City of Albuquerque

RE: REVISED ENGINEER CERTIFICATION FOR GOVERNOR BENT ELEMENTARY
(G18-D19) CERTIFICATION STATEMENT DATED 2/8/96.

ARCHITECTS • ENGINEERS • PLANNERS • INTERIOR DESIGNERS	
Date NOV. 13, 1991 Drawn by <i>[Signature]</i> Checked by <i>[Signature]</i>	Revisions 10/23/91
Project Name Project No. 32490 ALBUQUERQUE PUBLIC SCHOOLS GOVERNOR BENT ELEMENTARY SCHOOL REMODEL AND ADDITION 5700 HENDRIX NE, ALBUQUERQUE, NEW MEXICO 87110	
Sheet Title GRADING AND DRAINAGE PLAN	Sheet No. C1

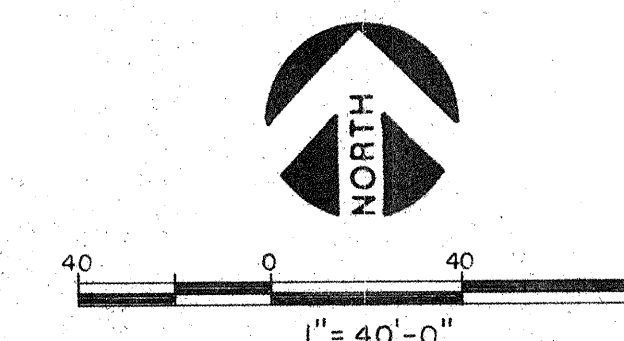
Based on the information provided on your February 9, 1996 resubmittal, Engineer Certification for the above referenced site is acceptable.
